Access Compliance Report Public Rights-of-Way (Curb Ramps)

Main Street: BEACH_BLVD Cross Street: ROCKWELL_AVE Location: SW

ADA ID: RPRK211005171638 Ramp Type: Type 7 - Directional 2 Initial Pass/Fail: Fail Overall Compliance: No Severity Score: 32

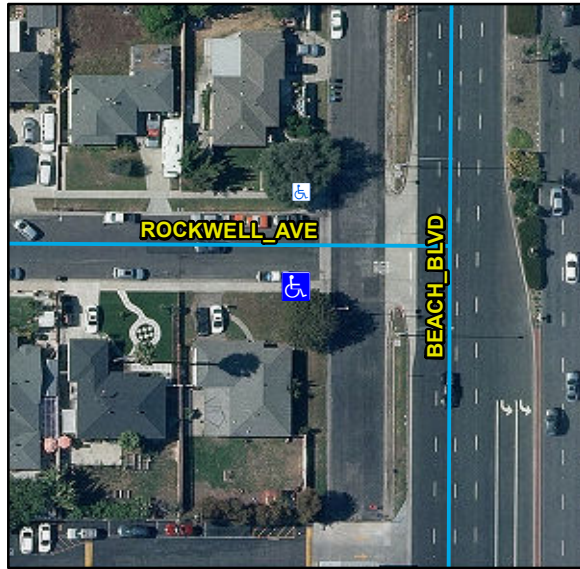
R304.2.2, R304.5.3, STD 1115

Remove & Replace Entire Ramp.
